**UNITED STATES
NUCLEAR REGULATORY COMMISSION
WASHINGTON, D.C. 20555-0001**

U.S. NUCLEAR REGULATORY COMMISSION
EVALUATION BY THE OFFICE OF NUCLEAR MATERIAL SAFETY AND SAFEGUARDS
OF THE CLASS 1 FINAL STATUS SURVEY REPORTS, LICENSE TERMINATION
ACTIVITIES AT THE REACTOR SITE, AND PARTIAL SITE RELEASE
FOR POSSESSION ONLY LICENSE NO. DPR-45
LACROSSESOLUTIONS, LLC
LA CROSSE BOILING WATER REACTOR
DOCKET NO. 50-409

Figure 8. Cross Section East View of L1-SUB-CDR, L1-SUB-TDS B, and L1-SUB-TDS A

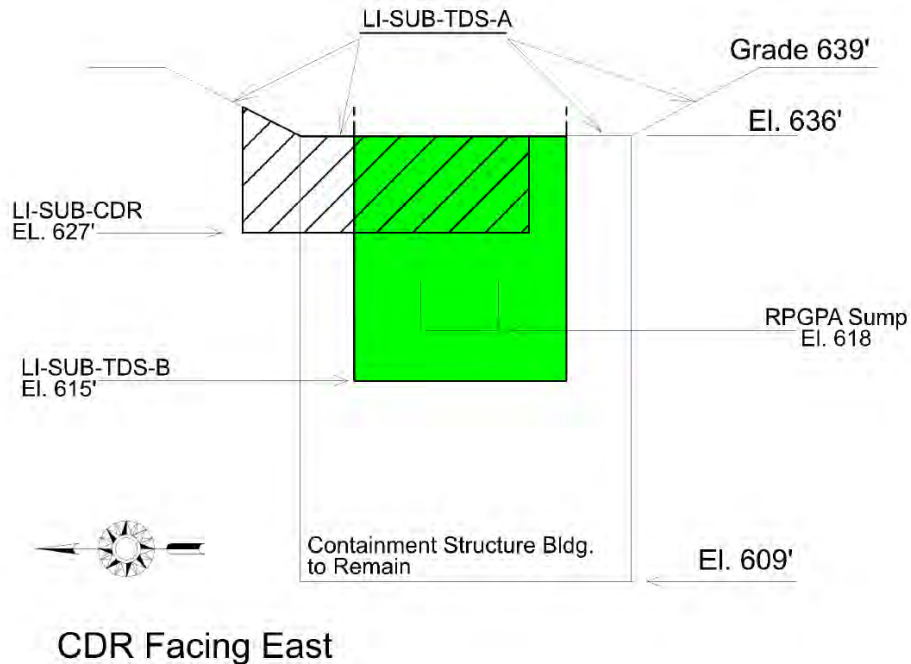
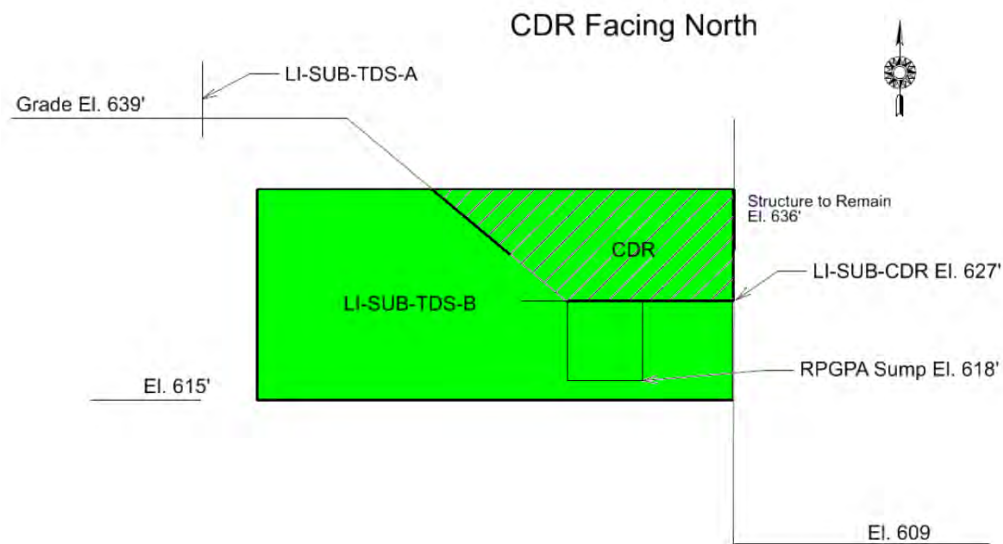
As shown in Figure 8 and Figure 9, the RPGPA sump area is at a lower elevation than Survey Unit L1-SUB-CDR, with the bottom of the sump trench box within Survey Unit L1-SUB-TDS B at an elevation of 618 feet. Therefore, the soil that had been scanned and sampled in the portion of Survey Unit L1-SUB-CDR that overlapped with Survey Unit L1-SUB-TDS B was later remediated and sampled as part of the Survey Unit L1-SUB-TDS B activities. In addition, Survey Unit L1-SUB-TDS A was at a higher elevation (636 feet – 639 feet) than Survey Unit L1-SUB-CDR (627 feet), and therefore the soil and samples that were taken in Survey Unit L1-SUB-CDR prior to the Survey Unit L1-SUB-TDS A activities remained at an elevation that was under the backfill that was initially used to fill in Survey Unit L1-SUB-CDR.

Figure 11. Survey Unit L1-SUB-TDS ORISE Confirmatory Survey Physical Boundary

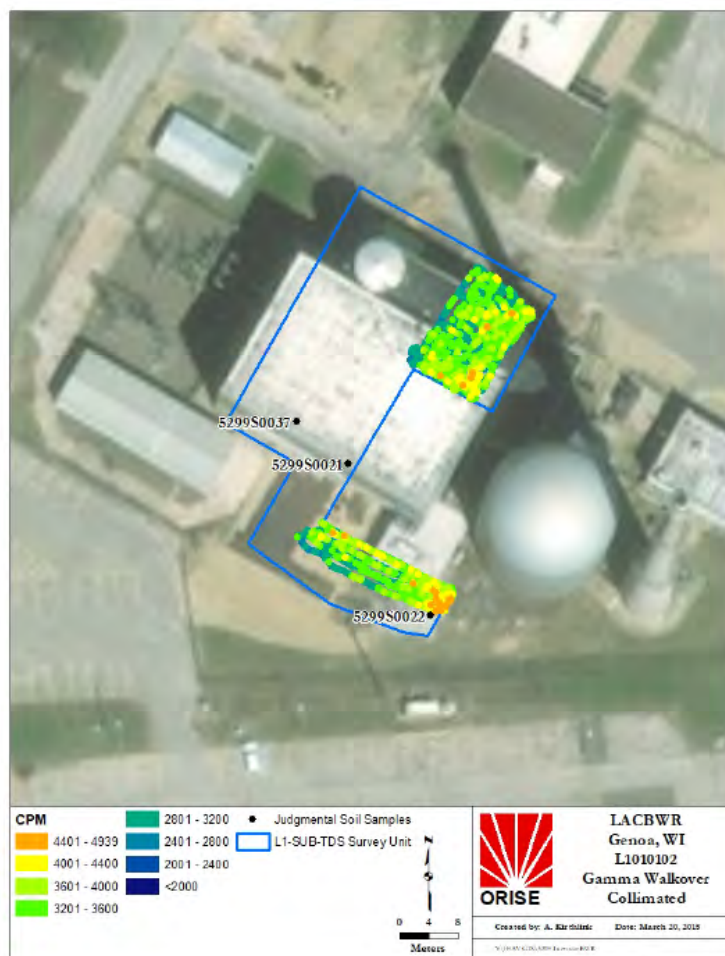
The ORISE survey report also stated that the post-survey review of the gamma walkover maps showed a discrepancy between the planned boundary for Survey Unit L1-SUB-TDS and the physical boundary observed in the field (Figure 11). Therefore, the NRC staff asked the licensee to confirm that the boundaries of the survey units surrounding Survey Unit L1-SUB-TDS share physical boundaries such that 100% of the soil area was investigated during FSS. The licensee confirmed that 100% of Survey Unit L1-SUB-TDS received a gamma walkover scan in the supplemental information provided in response to a clarification teleconference on July 7, 2022. Specifically, the licensee reviewed the FSS field logs for Survey Unit L1-SUB-TDS and confirmed that the areas not scanned by ORISE were scanned by LaCrosseSolutions survey technicians during FSS of the survey unit ([ML22269A392](#)).

Figure 18. WTB Original FSS Scan Lanes and Systematic Sample Locations

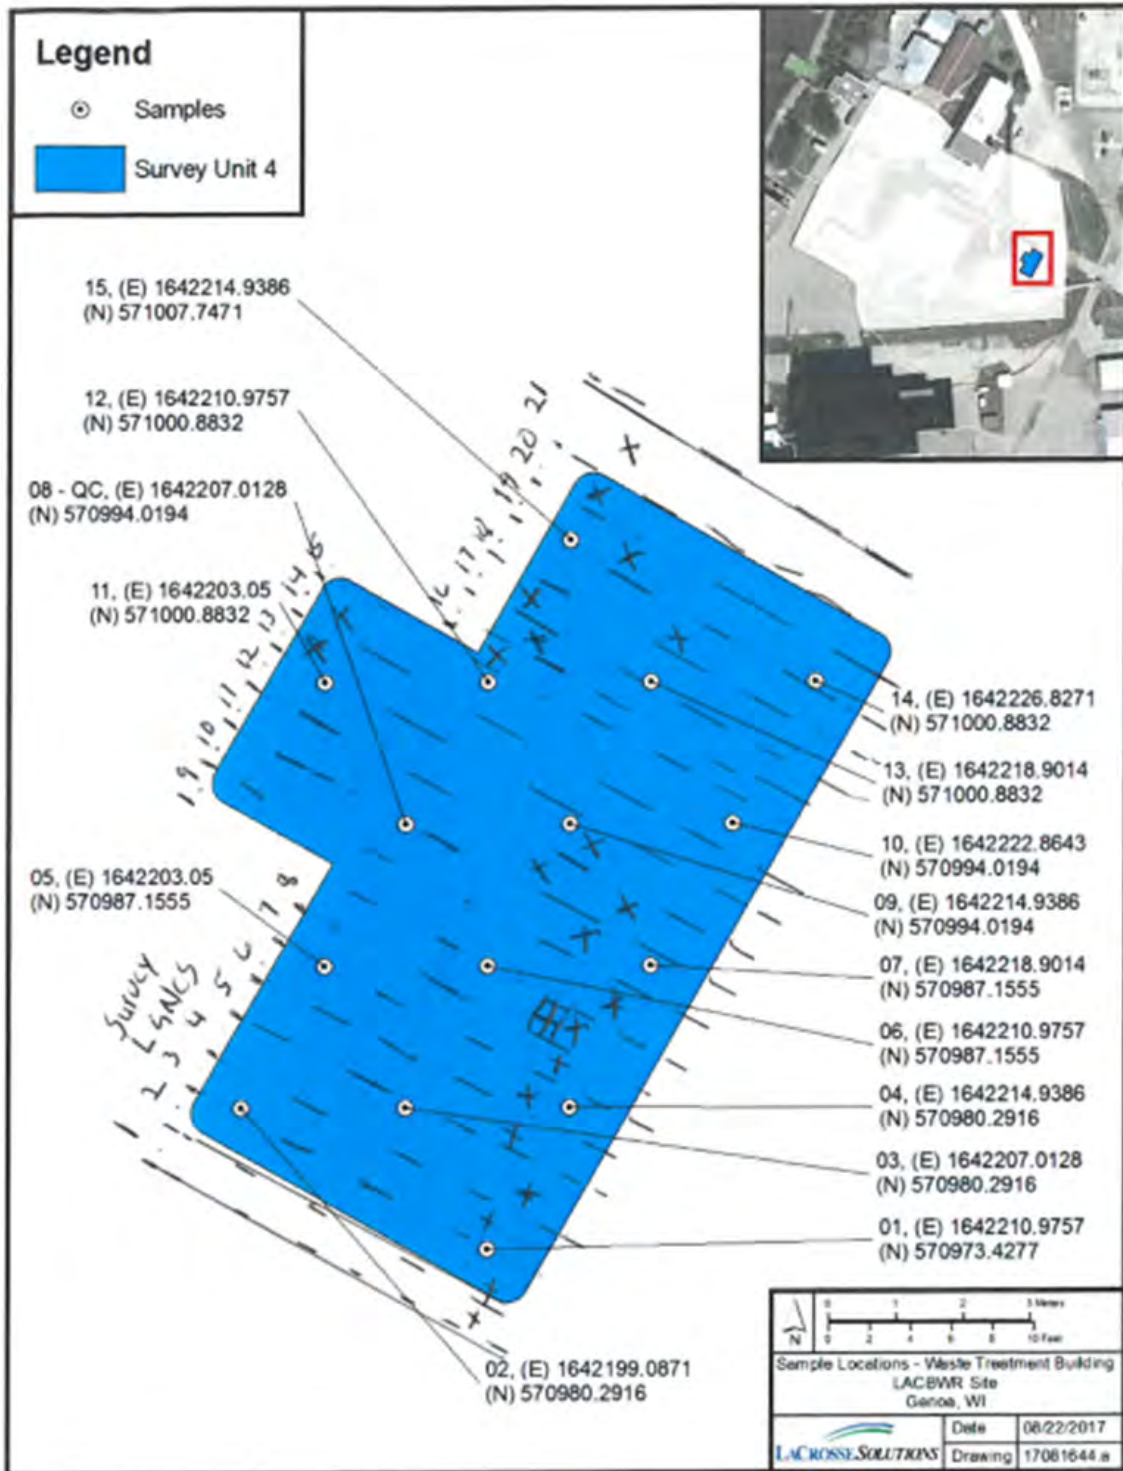
A systematic soil surface sample was not taken from scan lane 7, as shown in Figure 18. The NRC staff notes that even if a surface sample were taken, it may not have revealed the slightly buried contamination in that area of the survey unit due to the design of the FSS. Specifically, Section 6.5.2, "Soil," of the LACBWR LTP states that "there is low potential for significant subsurface contamination to remain in the end state with a geometry comprised of a clean soil layer over a contaminated soil layer at depth." The LACBWR LTP defines surface samples as

Figure 22. WTB Scan Lane Coverage for Scan Lanes “E” and “N”

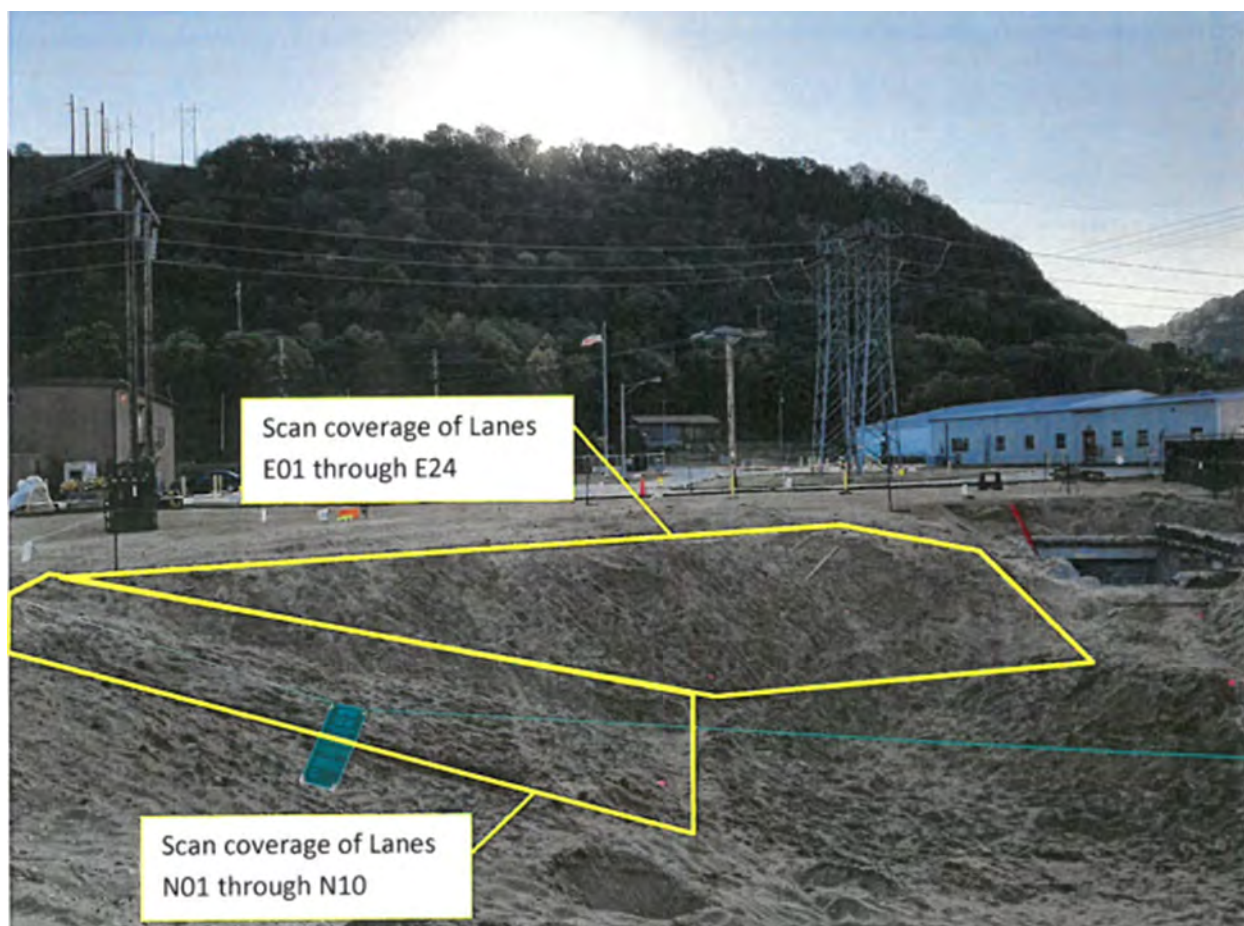
While the licensee could not reproduce a map of the scan lanes denoted as “E” and “N” in the FSS release record for the WTB excavation, a figure from the field logs was provided that depicts the general location and orientation of the “E” and “N” scan lanes but does not specifically show how each lane is demarcated. Figure 22 below shows a photograph of the scan coverage for lanes in the “E” and “N” survey areas, which consisted of the sidewall of the WTB excavation. In addition, Figure 20 above denotes the area (shown with a red dotted line) that was remediated via additional excavation due to areas with elevated radiological contamination being identified during the NRC inspection verification survey. Figure 20 also shows the scan lanes (shown in solid green) that are labeled as “EX” in the FSS release record. The “EX” scans were collected on September 14, 2017, and the licensee clarified that these scan lanes covered the remediated portion of the WTB excavation but not the entire survey unit. The 21 scan lanes identified by solid red lines in Figure 20 are the original scan lanes from the survey scan performed in the WTB excavation prior to remediation on September 12, 2017.

Table 8 reflects that nearly all the scan locations in the WTB excavation would have alarmed (i.e., exceeded the action level) using the environmental lab background radiation values of 5,004 cpm or 5,095 cpm plus the revised scan alarm action level value of 3,525 cpm. However, only two grid locations within the “E,” “EX,” or “N” scan lanes (E08 and N05) of the remediated area would have alarmed when assuming the average of the background radiation values from the nearby field (the average of background measurements for locations SP1 through SP13 is

6,489 cpm) plus 3,525 cpm, which gives a scan alarm action level of 10,349 cpm. The two locations that alarmed in this scenario (E08 and N05) were only slightly higher than the revised scan alarm action level when using the background radiation value from the nearby field. The NRC staff notes that several of the 1 m² areas around the GeoProbe sample locations, demarked (SP), were higher than the scan alarm action level, but these scan readings were of the clean fill and not part of the data that represents the end state of the subsurface soil.

Figure 24. Survey Unit L1-SUB-TDS A Surface Scan Lanes

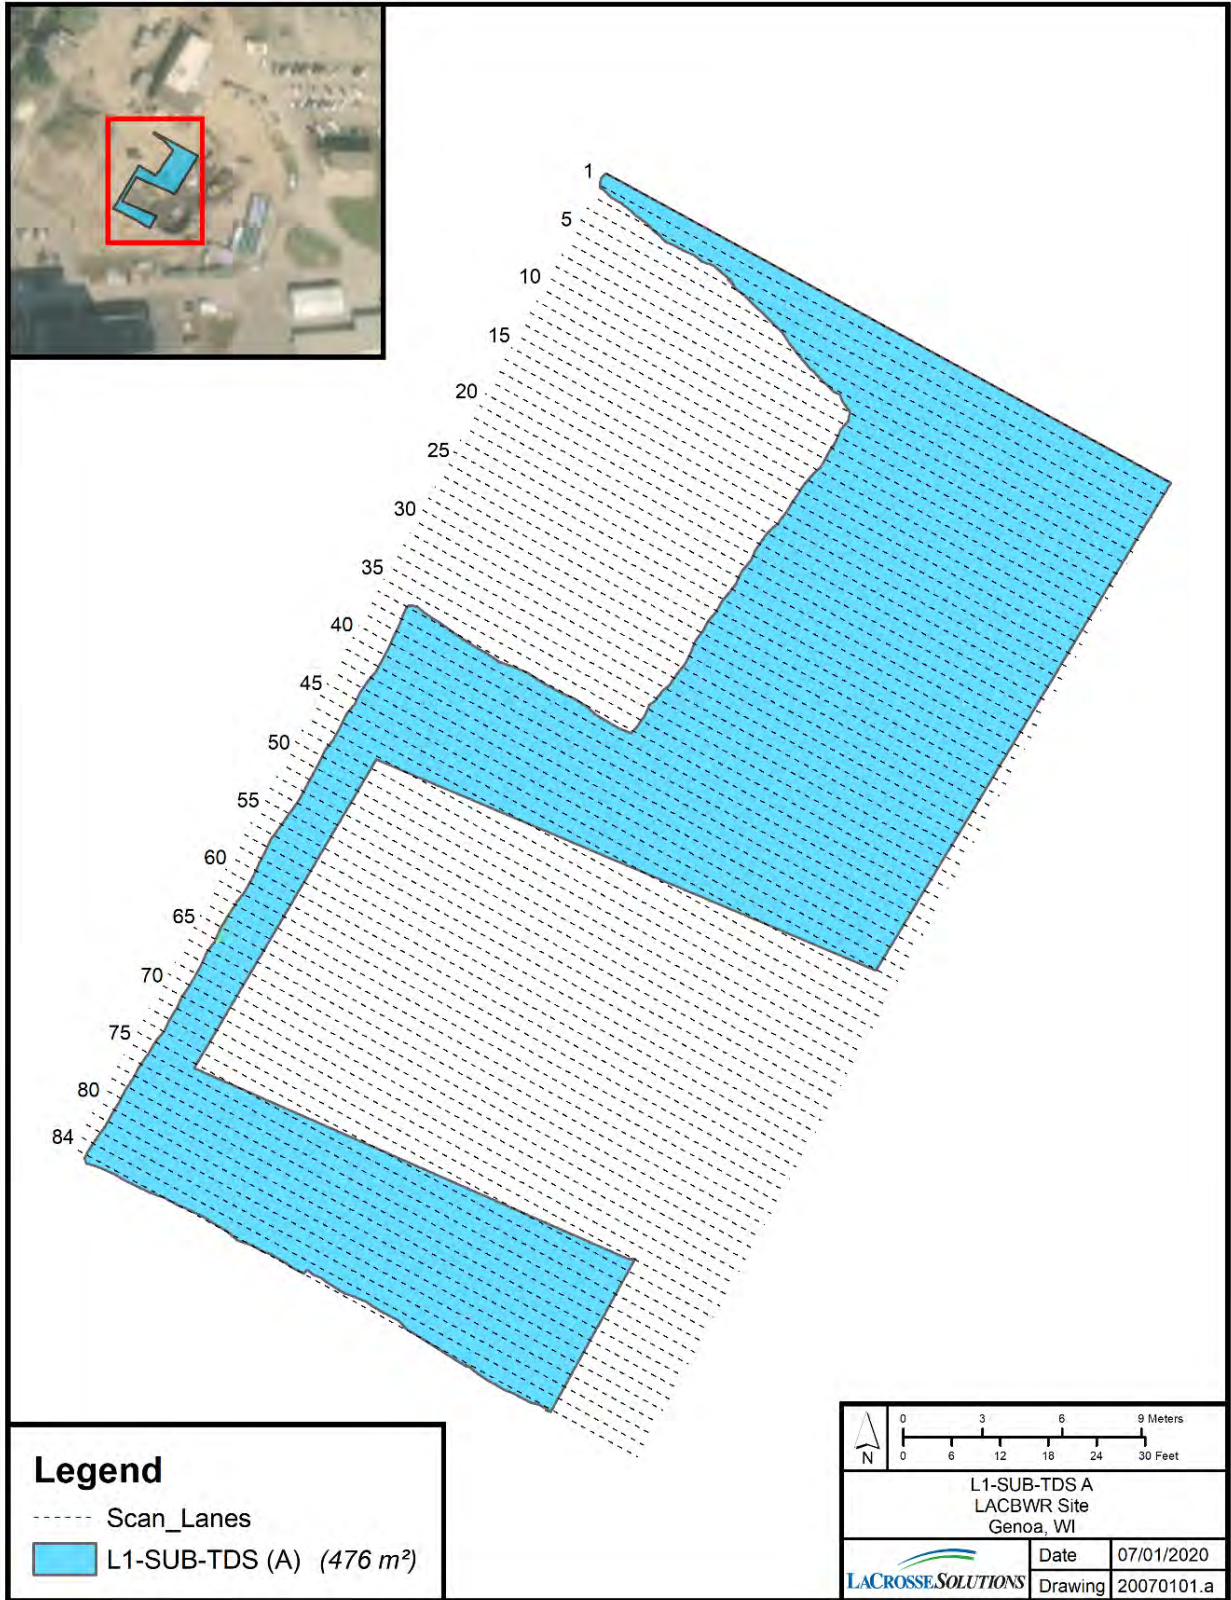
Given that additional remediation was conducted in Survey Unit L1-SUB-TDS A during FSS, the NRC staff requested that the licensee clarify the extent of the remediation, the location of the investigational soil samples, and the location of the judgmental soil samples. Specifically, the NRC requested a map of the surface scan locations in conjunction with the soil sample locations, and a clearer explanation of the investigations, remediation, and resurvey performed in Survey Unit L1-SUB-TDS A. The soil sample locations are indicated in Figure 13 of this safety evaluation. The surface scan locations for this survey unit are shown in Figure 24 below.

The NRC staff notes that the area around scan lanes 29 through 31 in Survey Unit L1-SUB-TDS A, which had the highest recorded surface scan readings, does not appear to have been remediated given the information in the revised FSS release record. However, the judgmental soil sample result in this location (sample location A19 with a concentration of 1.4 pCi/g of Cs-137), was well below the OpDCGL, as was the adjacent systematic soil sample result at sample location A9, with a concentration of less than 1pCi/g of Cs-137.

In response, the licensee revised the FSS release record for Survey Unit L1-SUB-TDS A to correct certain errors and provide additional clarification. The scan data in Table 7-1 of the FSS release record show that there were alarms for scan lanes 9, 22, 28, 29, 30, 31, 73, and 79. The revised release record clarifies that scan alarms triggered the collection of four investigational soil samples - one sample in scan lane 9, one sample for scan lanes 29 through 31, one sample in scan lane 73, and one sample in scan lane 79. The FSS release record states that in scan lane 22 and scan lane 28, the alarm was inadvertently logged since the field log states no alarm was produced on rescan and identifies that the licensee grouped certain scan lanes together with one investigational sample. As shown by the overlay of the surface scan lanes on the sample locations in Figure 25, the scan lanes with the highest survey readings in Survey Unit L1-SUB-TDS A correspond to investigational samples as matched in Table 13. In addition, the gamma spectroscopy results revealed that Cs-137 was positively identified in sample A19 (which was collected in scan lane 31) and sample A20 (which was collected in scan lane 9).

Figure 27. Survey Unit L1-SUB-TDS B RASS Sample Locations from December 9, 2017

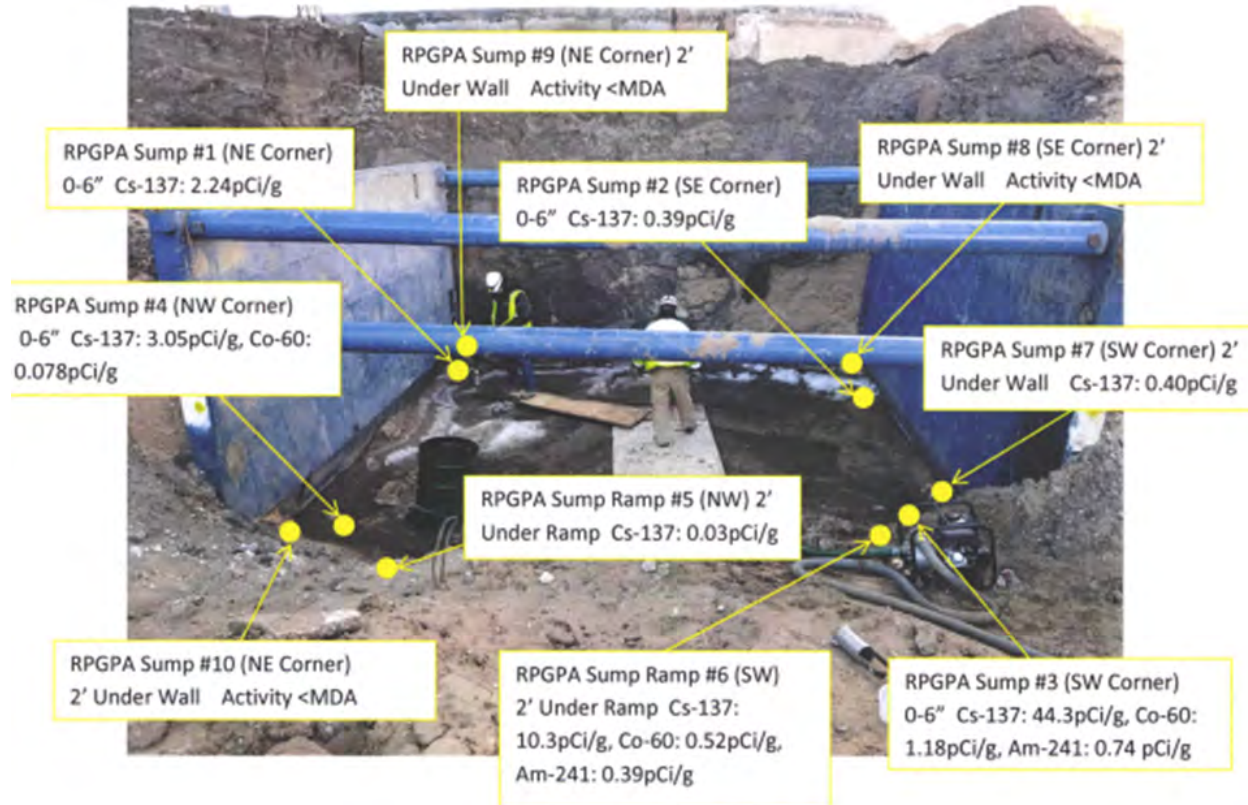
As part of its supplemental response to a request for confirmatory information ([ML22321A016](#)), the licensee indicated that when the trench box (shown in blue in Figure 27) was removed from the RPGPA sump area, there was significant sloughing from the excavation after removal of the trench box. The licensee stated that the contamination found outside of the RPGPA sump area was a result of the excavation activities to remove – and sloughing of the excavation after removal of – the trench box, as well as soil dropping from the trench box and removal equipment (i.e., excavator bucket) while the trench box was being lifted out of the excavation and moved out of the sump area. These activities spread contamination in the immediate vicinity of the RPGPA sump, including in the area where Sample L1-SUB-TDS-FSGS-B04-SB was collected, which resulted in a Cs-137 concentration of 24.4 pCi/g as shown in Table 15.

Therefore, it is reasonable to conclude that the GeoProbe sample locations where the maximum Cs-137 concentration occurred in the 624 to 627-foot layer of the soil sample was a result of this spreading of contamination during and after removal of the trench box, as opposed to contaminated backfill material being used in the RPGPA sump area.
